Product Change Notification

PCN number: PCN_FMB010_20190410_EN

Date: 2019.04.10

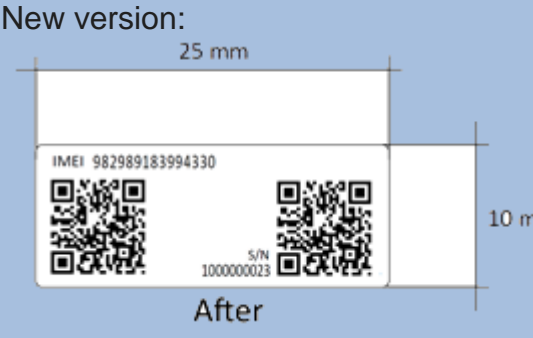
Change description	
Change type	Exernal/visual
	IMEI/SN info on device display change from barcode to QR
Detailed description	Old version:
	New version:
Change reasons	 <p>Before</p>
	 <p>After</p>
Product release date	QR format will increase reliability and minimize error rate, because of the error correction feature and improved reading in low contrast.
	Devices with new QR Code format will be released in manufacturing from June with 2 months of transition period. Over this period devices with barcode can be delivered as well as devices with QR code.

Change impact	
Risk assessment	Risk assessment for devices managment required
Suggested implementation plan	Due to changes in device information display we strongly recommend to check, and prepare your tools to read QR codes.
